ECE/TRANS/WP.29/GRPE/55
21 February 2008

Working Party on Pollution and Energy

**REPORT OF THE WORKING PARTY ON POLLUTION AND ENERGY
ON ITS FIFTY-FIFTH SESSION
(Geneva, 15 – 18 January 2008)**

" Figure 6: Positive Displacement Pump Dilution System

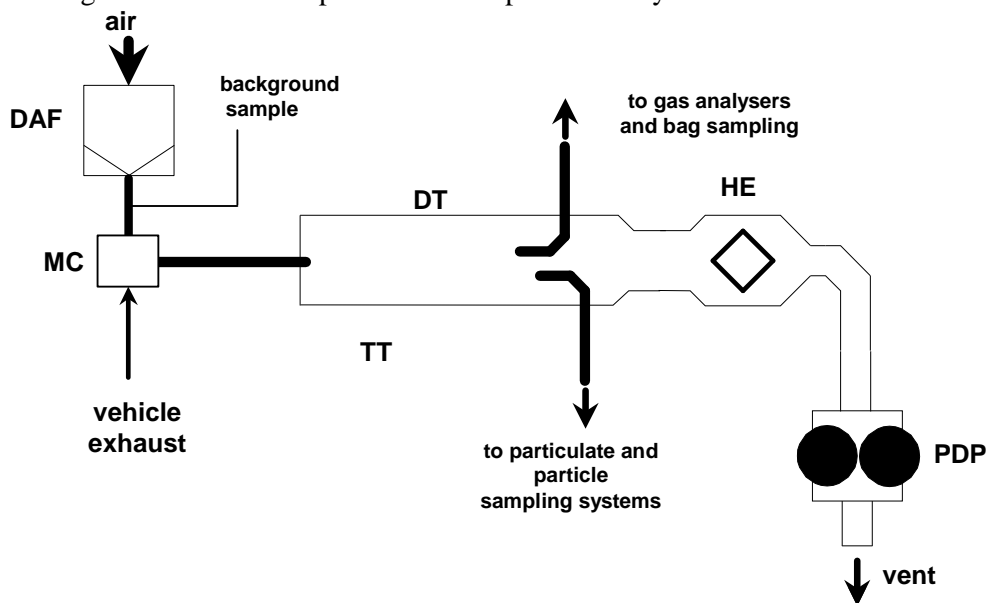
Appendix 2, paragraph 1.4.1., figure 6, amend to read:

Full Flow Dilution System with Positive Displacement Pump
